COUNTY OF EL DORADO
GREEN VALLEY CONVENIENCE CENTER
(PD12-0003)

Final Environmental Impact Report

STATE CLEARINGHOUSE NO. 2013062011

Alternative 1 – the pocket lane alternative referenced in the settlement agreement.

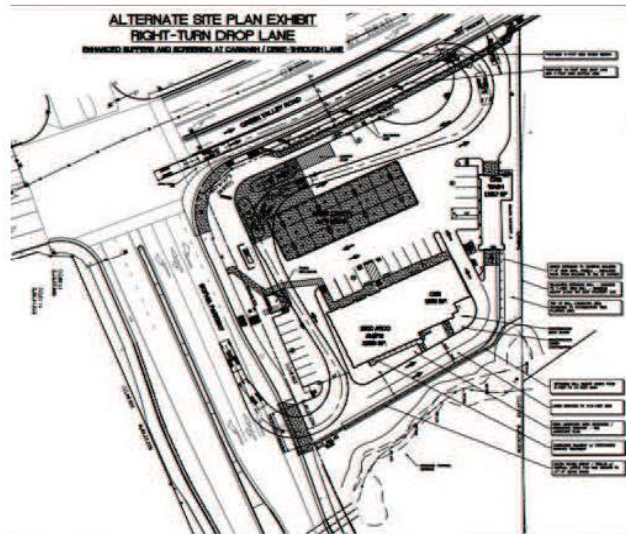
This alternative and diagram was provided by the ARCO developer's engineer. It was previously considered and subsequently approved by the Board of Supervisors on December 10, 2013.

Please analyze traffic impacts including intersection and turning geometrics for autos, autos with boat trailers, gas delivery trucks, and other general merchandise delivery vehicles.

There is no stipulation in the Settlement Agreement where the full deceleration lane should begin or its specific design. By definition, an intersection consists of the beginning of the curb return (BCR) to the end of the curb return (ECR). Thus, there is nothing that prohibits a deceleration lane from beginning at the ECR, as illustrated in Figure 2.0-2 and as evaluated in the Draft EIR. More importantly, a full deceleration lane beginning farther west (e.g., BCR), which would result in the creation of a third lane on Green Valley Road, is not a viable design option. Please see Master Response C.

Alternative 2 – illustration of the full deceleration lane alternative referenced in the settlement agreement. Note that it extends from the intersection of Sophia Parkway and Green Valley Road and continues the entire length of the developer's parcel.

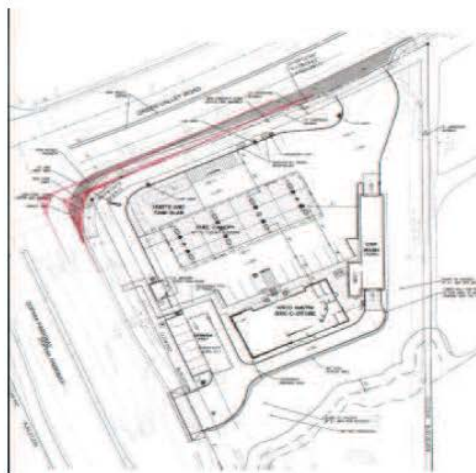
This alternative was described in detail during settlement negotiations. It requires moving the existing utilities along Green Valley Road in order to accommodate a dedicated lane to move traffic out of the through lanes for turning movements into the ARCO project (marks in red).
